# Stone Creek Vegetation Management Project (#65780) Scoping Comments

Please consider these comments for Stone Creek Vegetation Management Project scoping:

## Stone Creek Vegetation Management Project Roadside Hazardous Fuels Treatment Units and Mature / Old-Growth Stand Proximity

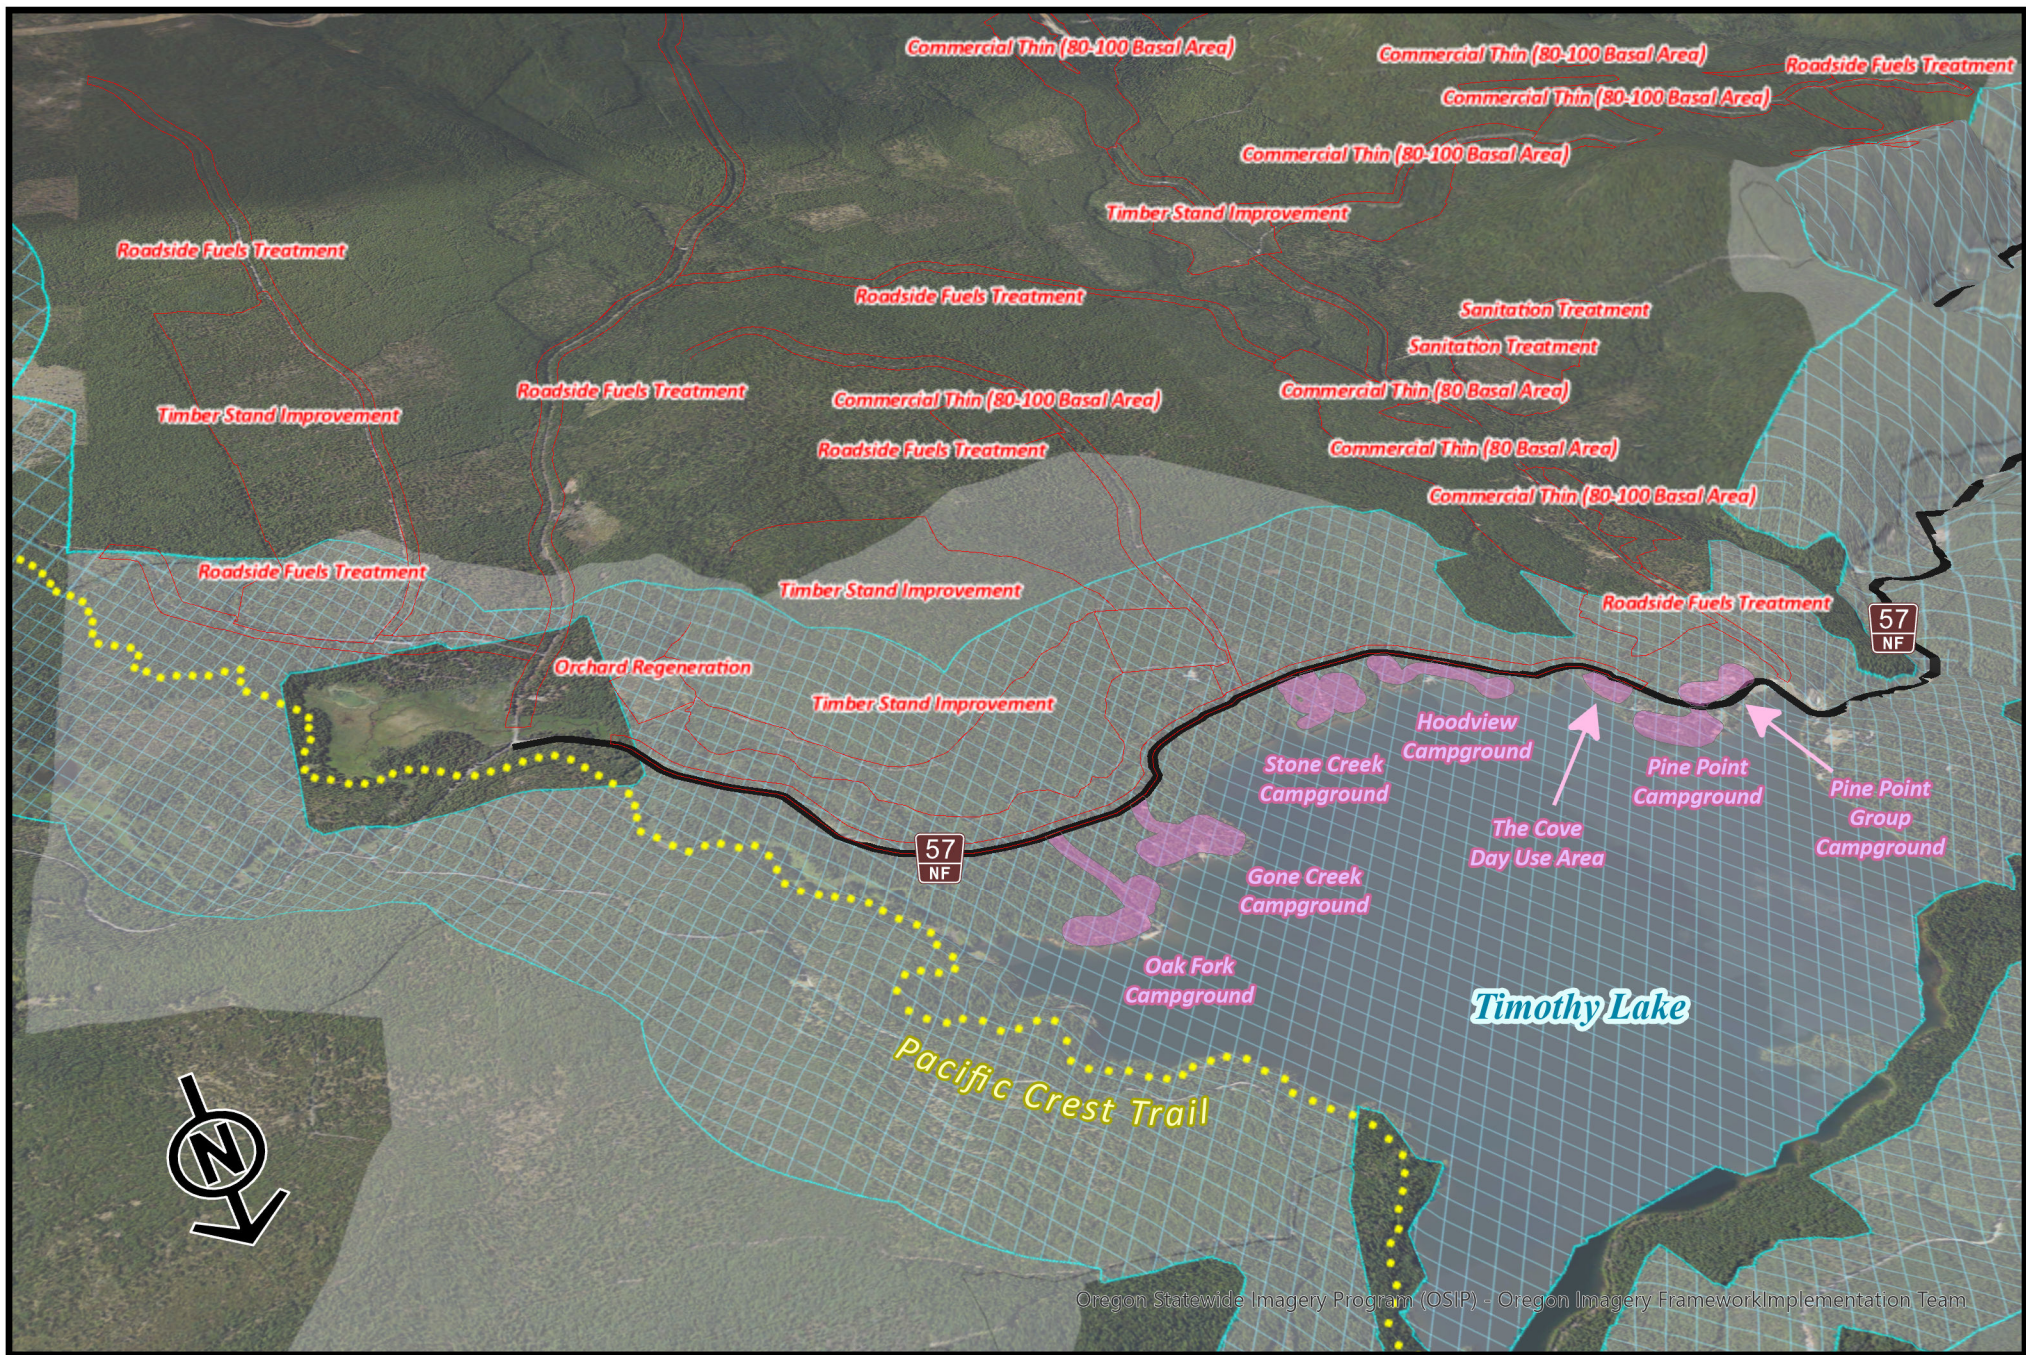
In addition to Commercial Thinning, the scoping letter mentions that the proposed roadside hazardous fuels treatment work will include the use of mechanized equipment. The scoping letter does not explicitly call out the age range of stands within the project area but does acknowledge that mature & old-growth plant communities exist within the project area. What steps will the Forest Service take to address potential noise impacts from their proposed activities? For context, the Washington Department of Transportation<sup>1</sup> has determined that noise impacts from machinery like chainsaws may lead to a “May Affect” or “Likely to Adversely Affect” at two distance thresholds:

- 195 Feet: This was the distance that WSDOT suggested was a disruption distance in early nesting season (Mar 15 – July 15) that might lead to an effects determination of Likely to Adversely Affect.
- 195 Feet – 0.25 Miles: This was the distance that WSDOT suggested was a disruption distance from March 1<sup>st</sup> through September 30<sup>th</sup> that may lead to a Not Likely to Adversely Affect / “May Affect” determination.

The attached figure highlights the roadside fuel treatment units along with their two distance thresholds for noise impacts. Will the Forest Service do any Survey & Manage surveys to identify any Northern Spotted Owl sites that may be impacted? My specific areas of concern would be:

Road Number	Beginning Milepost	Ending Milepost	Proposed Activity
42	8.47	8.61	Roadside Hazardous Fuels Treatment
42	10.00	10.12	Roadside Hazardous Fuels Treatment
42	10.9	11.3	Roadside Hazardous Fuels Treatment
4270	1.04	1.3	Roadside Hazardous Fuels Treatment
5730-230	0.78	0.9	Commercial Thinning (80-100 BA)
5740	2.65	2.7	Roadside Hazardous Fuels Treatment
5740-230	2.63	2.63	Roadside Hazardous Fuels Treatment
